# Clause 45 PHY Registers for 802.3ch and Precoder Testing

IEEE P802.3ch MultiGigabit Automotive  
Ethernet PHY Task Force

2 Nov 2018

# Easy precoder test

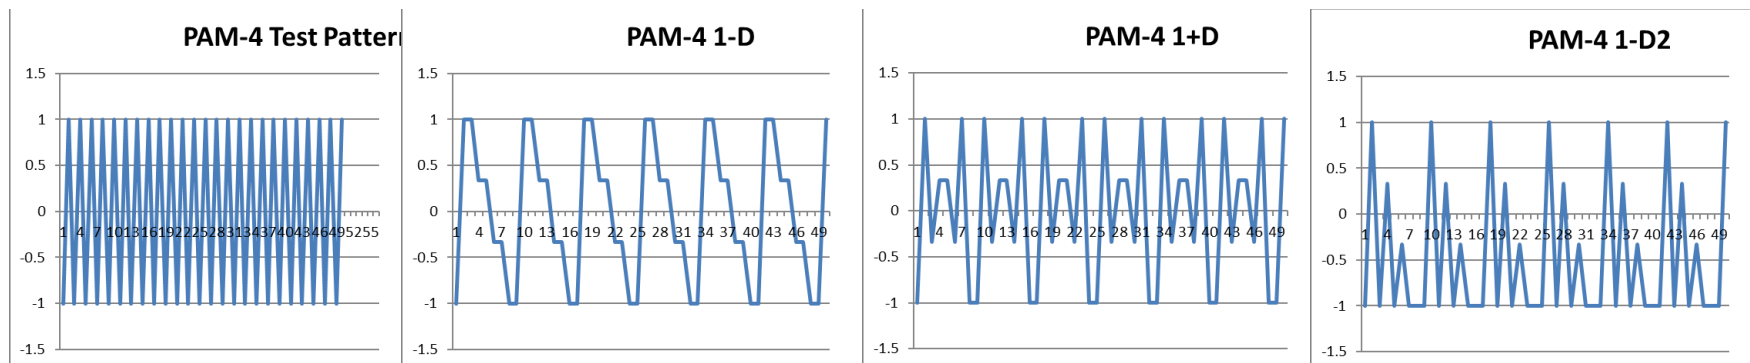
- Simple {0,3} repeating sequence generates nice periodic patterns from the precoder options – easily distinguishable

*Change Table 149-7 4<sup>th</sup> body row (value 011, page 89 line 10) to be “Test mode 3 – Precoder test mode”*

Test mode 3 is not defined and the corresponding register is reserved for future use for testing the precoder operation. When test mode 3 is enabled, the PCS shall generate a continuous pattern of {0, 3} symbols to be input to the PMA, precoded according to the Transmit precoder settings as determined by the value set in register 1.2309:10:9, or, equivalent functionality if MDIO is not implemented, and transmitted by the PMA timed from its local clock source.
